South Texas Project Electric Generating Station P.O. Box 289 Wadsworth, Texas 77483

April 24, 2000
NOC-AE-00000838
STI: 31093848
FILE NO: Z18
ER 20000082
10CFR50.4(b)(5)
10CFR50 App E

STP NUCLEAR OPERATING COMPANY
Units 1 and 2
Docket Nos. STN 50-498; STN 50-499
Changes to STPEGS Emergency Plan

Summary of Changes for STPEGS Emergency Plan Revision 19

FIGURE C-2
PAGE 1 OF 3

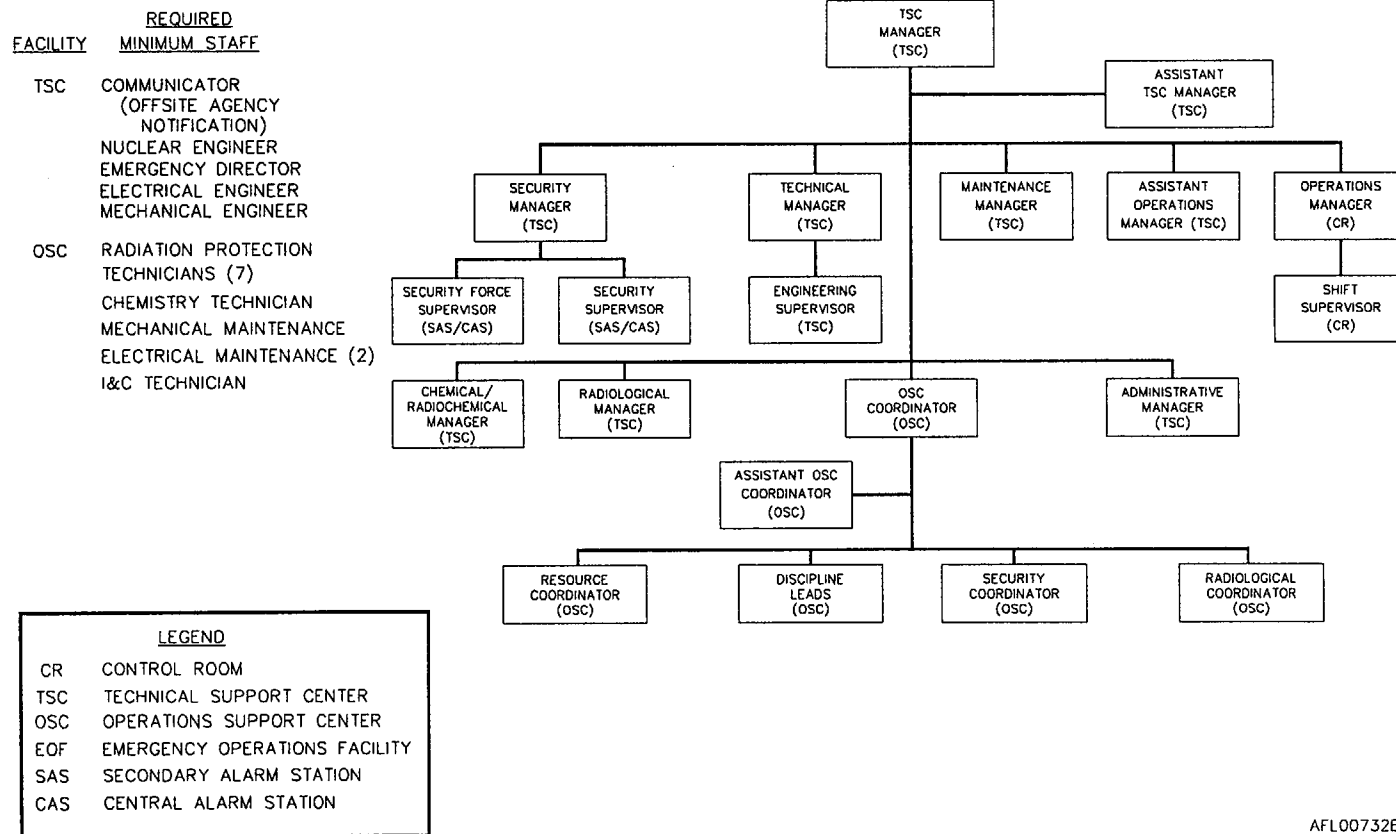
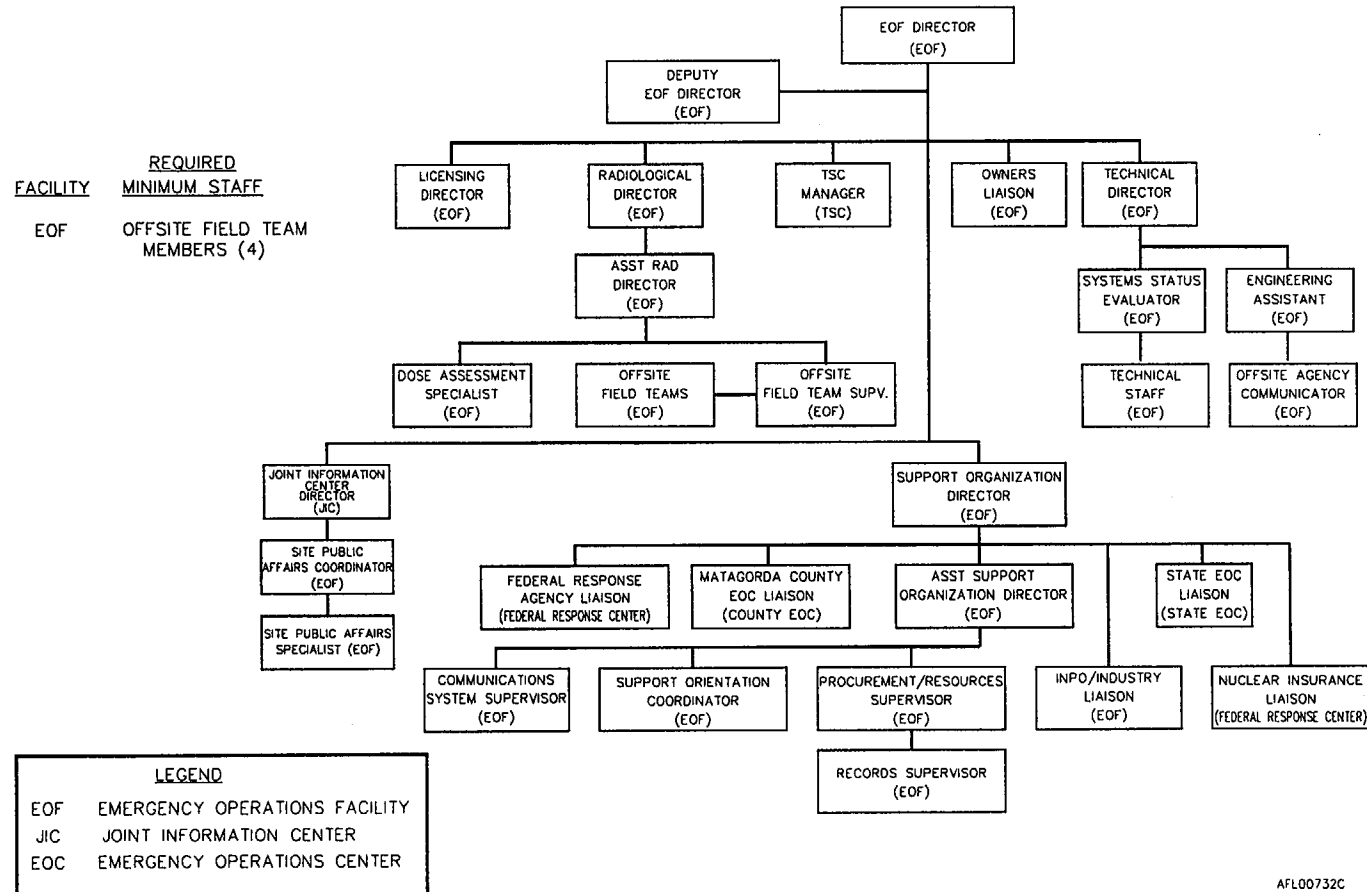
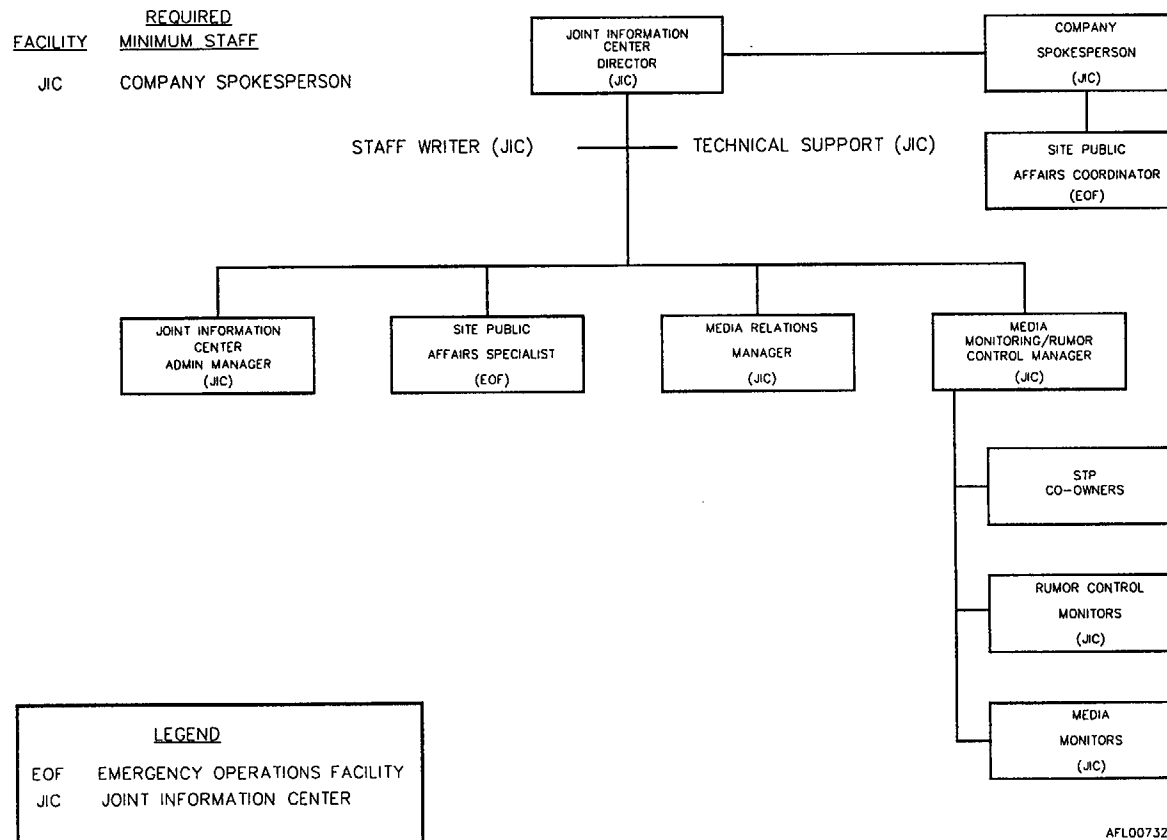
33	Figure C-2, Page 15, Control Alarm Station changed to Central Alarm Station. Wording is wrong.	Editorial change
34	Figure C-2, Page 15, Added TSC to Assistant Operations Manager box.	Editorial change
35	Figure C-2, Page 16, Changed MIC to JIC, revised legend, removed Corporate Central Evaluation Center Director.	Title Change, HL&P is now part of the Co-Owners and not responsible for media relations prior to JIC activation, this is done at the EOF.

NO.	CHANGE TO REV. 18	REASON
36	Figure C-2, Page 17, Senior was removed from Senior Staff Writer.	Title Change.
37	Step D.3.2, Page 4, Replaced Media Information Center with Joint Information Center.	Renaming the Media Information Center to be consistent with industry standard.
38	Step E.2.2, Page 2, Replaced Media Information Center with Joint Information Center.	Renaming the Media Information Center to be consistent with industry standard.
39	E.3, Page 4, Changed tone alert radios to alert radios.	The technology has changed from a tone signal to a digital signal.
40	Addendum E-1, Step 3.1.2, Page 8, Houston Lighting & Power Company changed to Reliant Energy.	Editorial name change.
41	Addendum E-1, Step 3.1.2, Page 9, Houston Lighting & Power Company changed to Reliant Energy.	Editorial name change.
42	Figure E-1, Page 1, Updated map.	Map updated to bring current with changes (5/28/98 revision).

FIGURE E-2

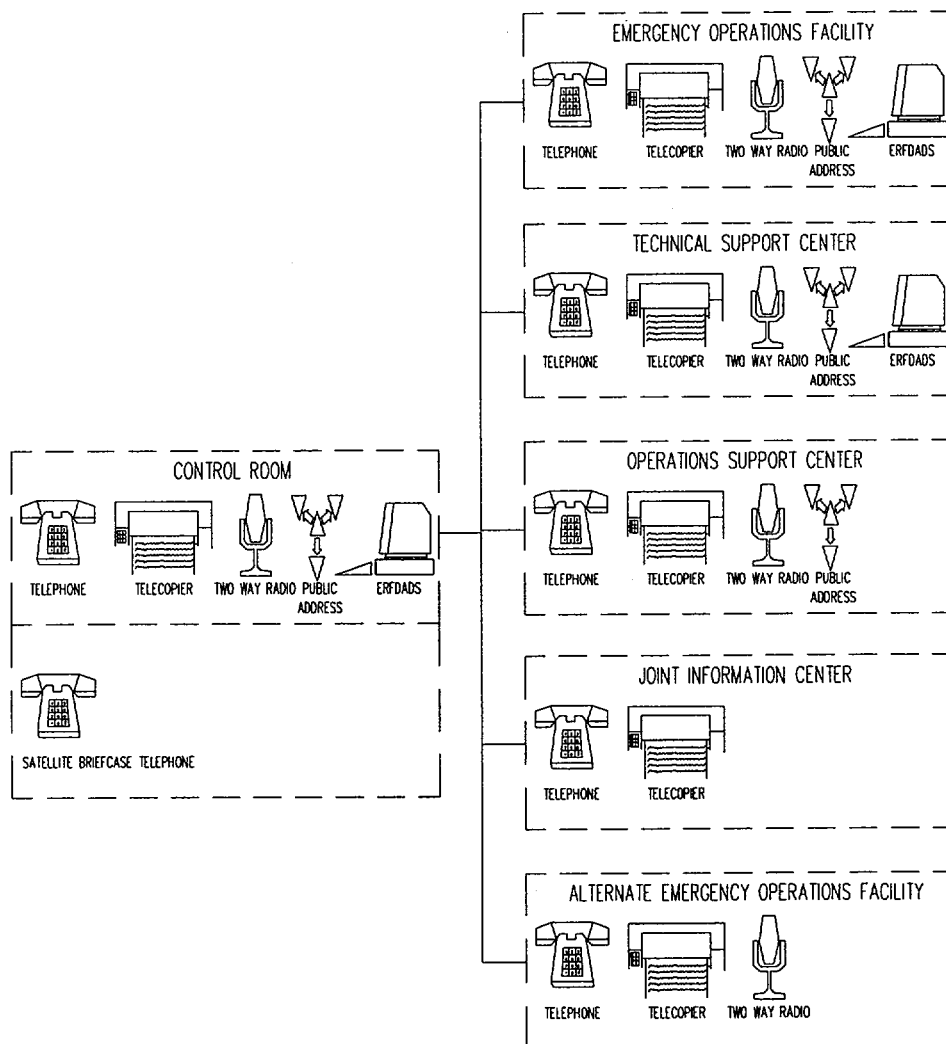
43	Figure E-2, Page 11, Replaced Media Information Center with Joint Information Center.	Renaming the Media Information Center to be consistent with industry standard
44	Step F, Page 1, "Assignment to the ..." was added to the beginning of sentence.	The wording is being changed to clarify the tie between the Emergency Plan and the procedure.
45	Step F.7.1, Page 4, Removed the word required.	Editorial change, these actions are typical.
46	Step F.7.1, Page 4, Removed "in accordance with established Public Affairs procedures and Section K of this Plan".	Editorial change, to make the sentence consistent.
47	Step F.7.2, Page 5, Last bullet, replaced Media Information Center with Joint Information Center.	Renaming the Media Information Center to be consistent with industry standard.
48	Step F.7.3, Page 7, Replaced Media Information Center with Joint Information Center in two paragraphs.	Renaming the facility is consistent with industry standards.

FIGURE G-1

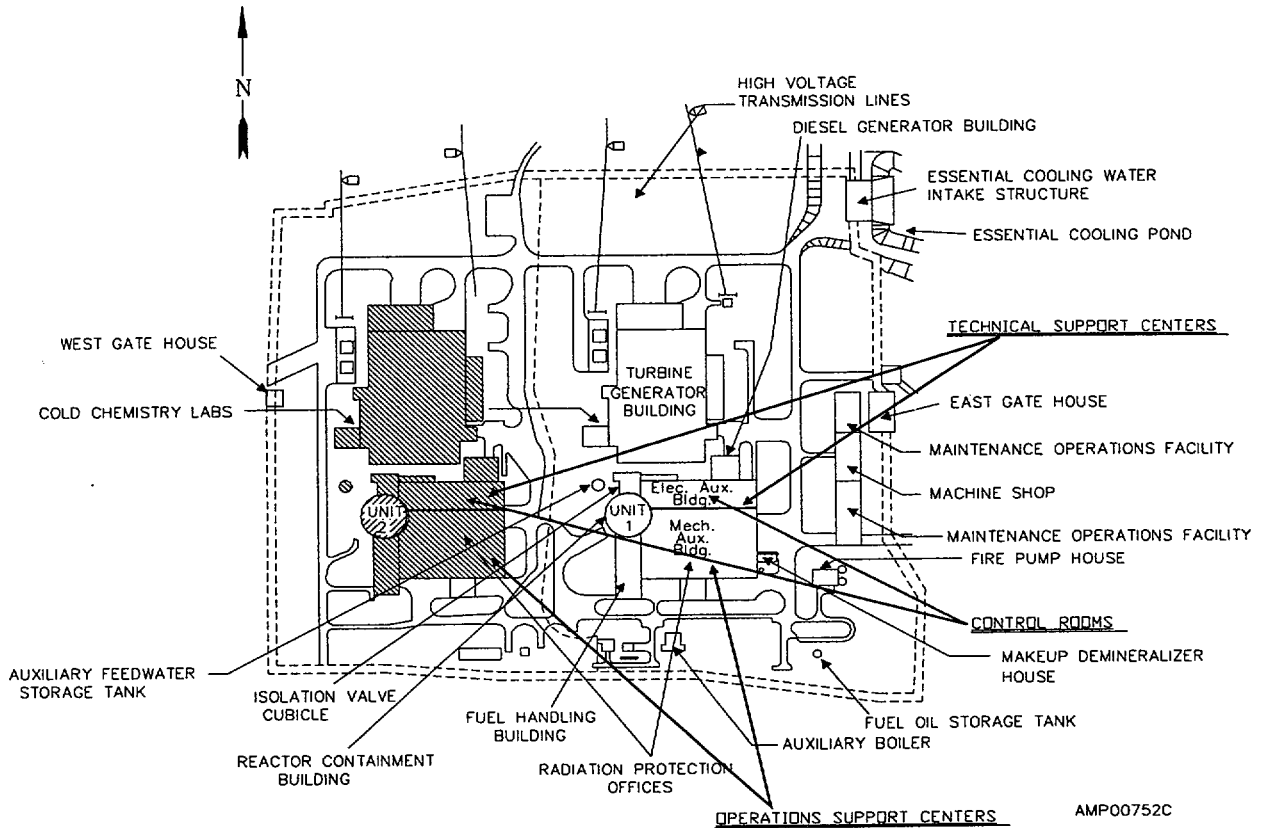
NO.	CHANGE TO REV. 18	REASON
67	Step G.9, Page 7, Changed Yankee Atomic Electric Company to Duke Engineering.	Changed Letter of Agreement/contract from Yankee Atomic Electric Company to Duke Engineering.
68	Figure G-1, Page 9, Add the word LOCATIONS to the title.	Editorial Change.
69	Figure G-2, Page 10, Remove the word LOCATION from the title.	Editorial Change.
70	Table G-1, Page 17, Revised directions to where portable air samples are stored.	Portable air samplers are stored at the HP 41' Access Control Point.
71	Table G-1, Page 18 Replaced Decon Powder with Abrasive Soap.	Revised Hospital decontamination supplies to reflect actual material.
72	Table G-1, Page 20, Last sentence on page, changed as described to as listed.	Editorial Change, clarification.
73	Step H.3, Page 5, Changed whole body dose to exposure.	Editorial Change, Manual of Protective Action Guides and Protective Actions for Nuclear Incidents has been revised.

FIGURE K-1

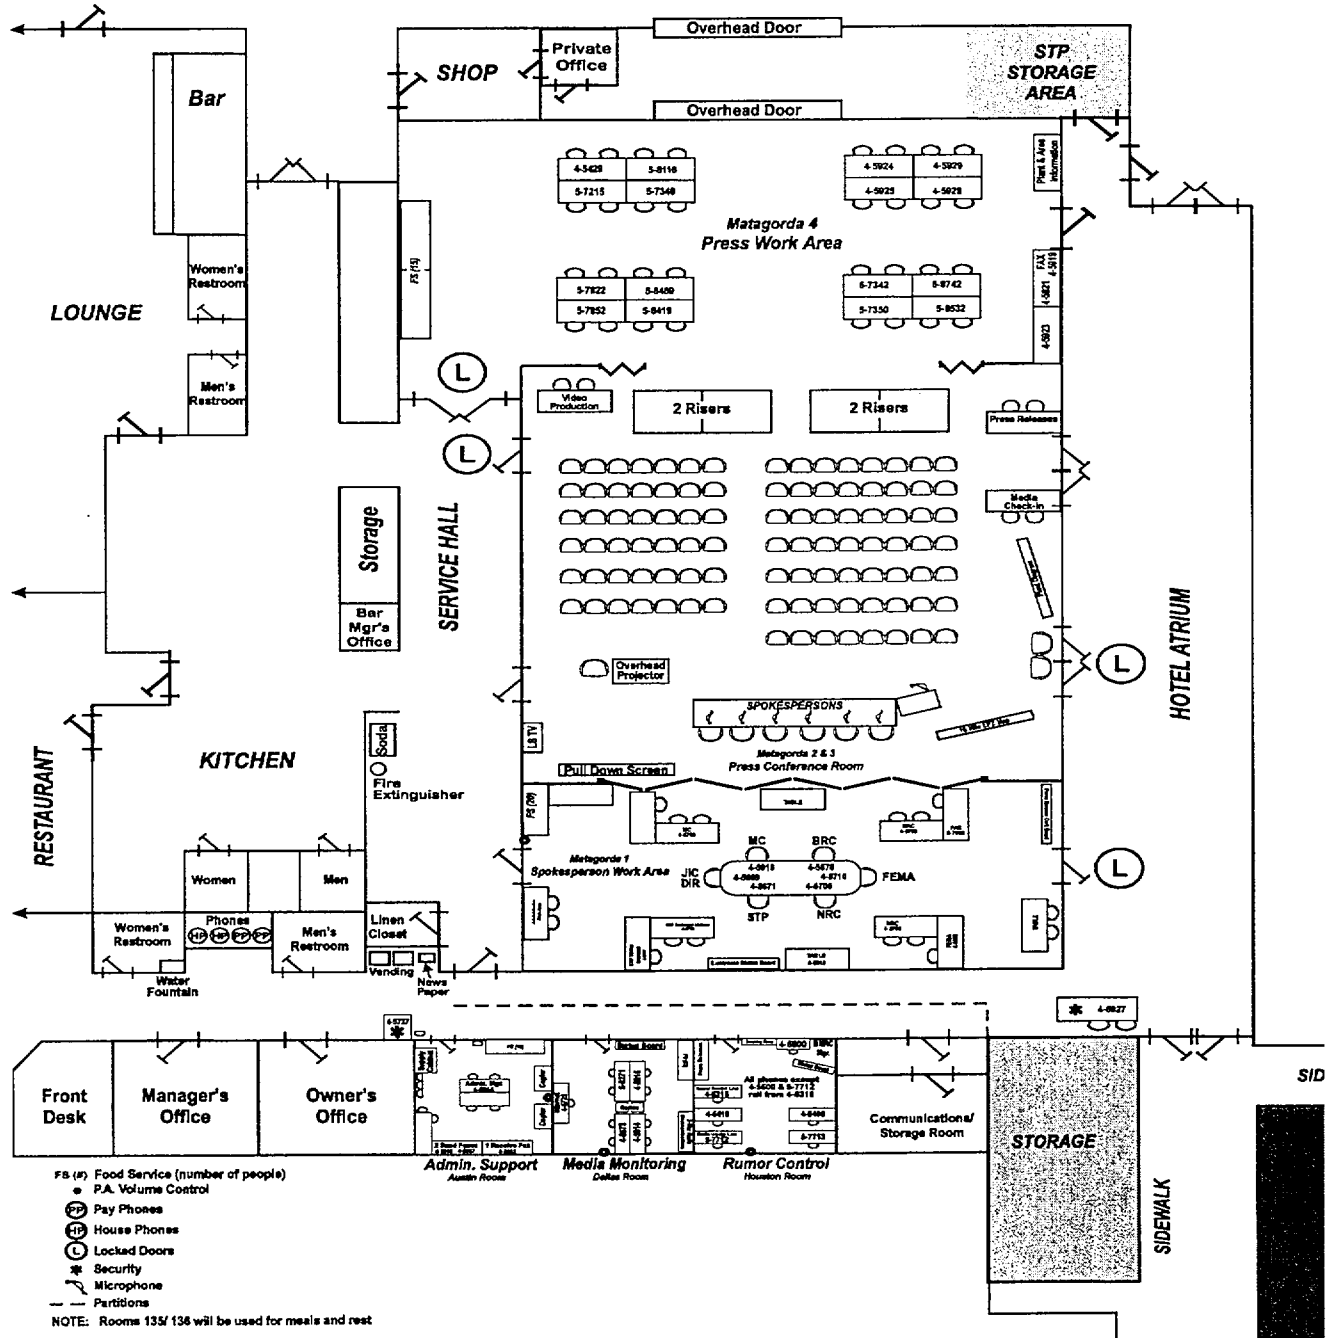
98	Figure K-1, Page 6, Map revised and made typical.	Renaming the facility is consistent with industry standards.
99	Step M.1, Page 1, Removed mention of Drill and Exercise procedure.	There is no description of a Training Program in the Drill Procedure.
100	Step M.2, Page 2, Changed Manager, Emergency Response to Supervisor, Emergency Response.	Changed responsibility from Manager, Emergency Response to Supervisor, Emergency Response.
101	Step M.2.3, Page 2, Revised ERO requalification statement to include drill/exercise participation, coaching, mentoring, controlling, or evaluating.	Enhancement to the requalification process for ERO members. This process provides an opportunity for ERO members to participate in a meaningful proficiency enhancing evolution and receive requalification credit.
102	Step N.1.3, Page 1, Changed Manager, Emergency Response to Supervisor, Emergency Response.	Changed responsibility from Manager, Emergency Response to Supervisor, Emergency Response.
